CLAREMONT BUSINESS PARK 2 FIL. NO. 1 - LOT 4

EL PASO COUNTY, STATE OF COLORADO
GRADING & EROSION CONTROL PLAN

GRADING & EROSION CONTROL PLAN
CLAREMONT BUSINESS PARK 2 FIL. NO. 1 - LOT 4
JOB NO. 44-037
DATE PREPARED: FEBRUARY 15, 2021
DATE REVISED:

SHEET 2 OF 3

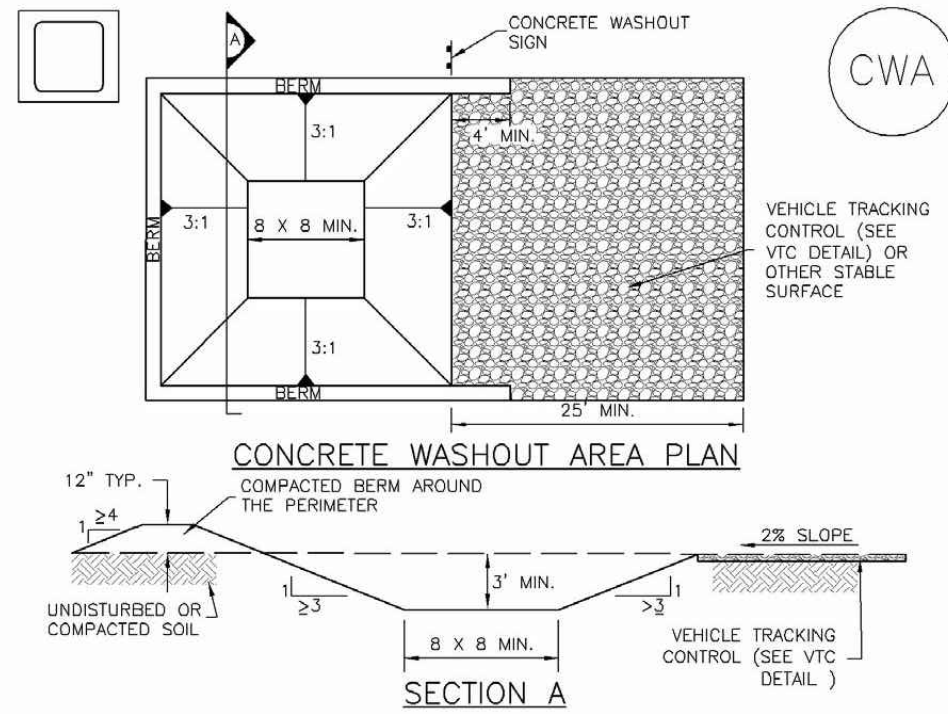
show areas of temporary and permanent seeding.
add symbol to legend

Add a note about existing vegetation and percent cover (prior to early grading).

Add a note stating no asphalt/concrete batch plants are associated with this project.

Add a note stating there are no springs, streams, or wetlands at the Site.

Label all proposed temporary construction control measures by phase of implementation (initial, interim, final)

If "limits of disturbance" and "construction boundary" are the same, change to "construction boundary/limits of disturbance" or otherwise show as separate line types for each on the legend and figure.

Please update plans to show proposed cut and fill sections. Also include a linestyle for it.

Per approved construction drawings (SF-2014), show sidewalk around driveway.

Provide location and details of temporary sediment basin, including riser pipe perforation sizing, number of rows, required volume, and tributary area to the sediment basin.

Please adjust limits of disturbance to include any sections where curb and gutter or asphalt will be installed.

Please label where the limits/edge of asphalt are on the east portion of the lot.

Provide cross section for channel. The cross section shall include offset dimensions from the property lines.

No temporary seeding is anticipated for this project. As to not overly encumber the plans, please see the landscaping plans landscaping and seeding information for this project

No Temporary sediment basin is proposed for the development of this lot.

CAUTION!! NO GRADING SHALL OCCUR THROUGH ELECTRIC AND TELEPHONE EASEMENT. ALL ELEVATIONS THROUGH THE EASEMENT SHALL NOT BE MODIFIED WITHOUT PRIOR APPROVAL. CONTRACTOR SHALL BE CAUTIOUS OF EXISTING UTILITIES DURING THE PAVING STAGE.

ADDED
continue silt fence
